## TOLEDO - LUCAS COUNTY PLAN COMMISSIONS

REF: SUP-4010-22

SUBJECT: Special Use Permit for a School at 2416 Seaman Street

SITE PLAN

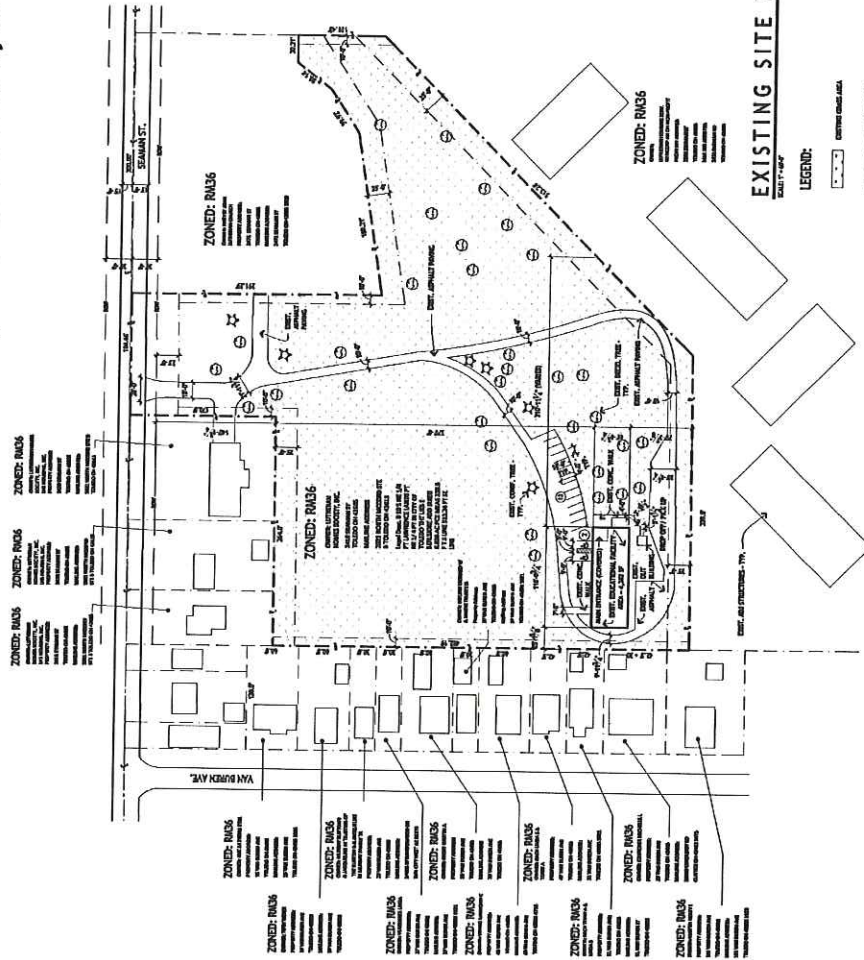
The site includes an existing parking lot with thirteen standard (13) parking spaces, two (2) auto accessible spaces, and a drop off pick up area. The parking lot is accessed from Seaman Street via a driveway leading to the rear of the property. The parking area is set up as a loop around the structure. If one has not already been established, a cross access agreement shall be required for the two parcels sharing the driveway with the site. The Division of Transportation has provided conditions of approval, listed at the end of this report, to bring the parking lot closer to compliance with the current Toledo Municipal Code Parking and Circulation standards.

Furthermore, institutional uses such as schools have walkway requirements to ensure safe pedestrian flow. A paved walkway, at least five-feet in width, shall be provided from Seaman St to the building per TMC§1109.0204.

18. Bicycle parking is required per TMC 1107.0900.
19. Sidewalks are required along Seaman per TMC 1107.1300
20. Van and auto accessible parking spaces are required to be a minimum of 9'x18' with a 5' loading aisle for auto and 8' loading aisle for van per TMC 1107.1700
21. Wheel stops are required at property lines, sidewalks, planting strips and builders per TMC 1107.1907.
22. Dumpster locations must be shown per TMC 1107.1910.
23. Driveway needs to be 25' wide from street to the driveway fork for two-way traffic per TMC 1107.1911
24. Angled parking is required for the one-way direction pattern around the building per TMC 1107.1911.
25. "Do Not Enter" signage and directional arrow pavement markings are required at the driveway fork for one-way traffic pattern around the building.

26. A cross access agreement shall be established and recorded between all properties sharing the driveway if one has not already been established.
27. Per TMC§1107.0400, Off-Street Parking Schedule "A" requires one parking space per ten (10) students, plus one (1) per faculty member, plus one (1) per three (3) staff members plus one (1) space per fifty (50) students for student drop-off and pick-up. At least ten (10) spaces are required. **Acceptable as depicted.**

28. Per TMC§1107.0400, Off-Street Parking Schedule "A" requires one (1) bicycle parking slot per three (3) students as well as one (1) spot per ten (1) sparking spaces for faculty and staff. **Not acceptable as depicted. Applicant shall provide a bicycle rack with at least ten (10) spaces.**

30. Per TMC§1107.1700 Accessible Parking for Physically Disabled Persons one (1) van accessible space is required. **Not acceptable, none depicted.**
31. A detailed site, lighting, fencing and four (4) copies of a landscaping plan (separate from building & site plans) shall be submitted to the Plan Director for review and approval. Such plan shall include **No modifications are proposed, site plan acceptable as depicted. Note conditions below for any future development:**

- f. The location, lighting, and size of any signs.
32. Dumpster location(s) shall be clearly defined, have a concrete pad and be surrounded by a solid wooden fence or a masonry screen enclosure with landscaping and shall not be located in any required setbacks. Dumpsters may not be located in the public right-of-way. **Acceptable as depicted.**
